Access Compliance Report Public Rights-of-Way (Pedestrian Signals)

Main Street: **KELLOGG_DR** Cross Street: **MOUNTAIN_VIEW_AVE** Location: **N**

ADA ID: **SGAT210922124131** Signal Type: **One Push Button-Non APS** Overall Compliance: **No** Severity Scores: **BTN 1: 10** **BTN 2: N/A** **No BTN: N/A**

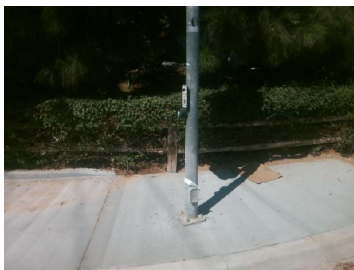
OC Std/PROW: **MUTCD 4e.08**

Possible Solutions: Replace Signal Push Button With APS Button.
